Sheet: /
File: stylophone-board.kicad_sch

Title: Stylophone

Rev: 0.1

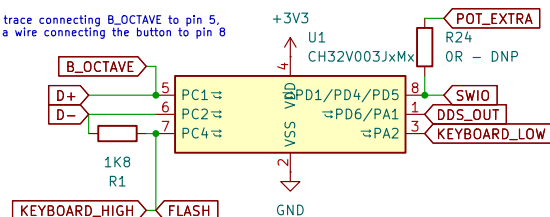
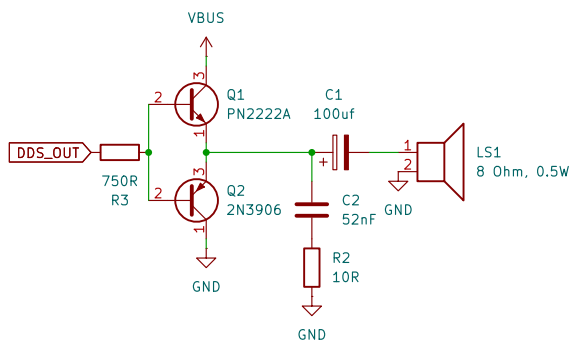
Cut the solder trace connecting B_OCTAVE to pin 5, instead solder a wire connecting the button to pin 8

Mistakes that made it to the production:
The resistor must be connected between 3v3 and PC2 instead
(this can be fixed on board by connecting the upper leg of the resistor to left pin of a C5 instead)
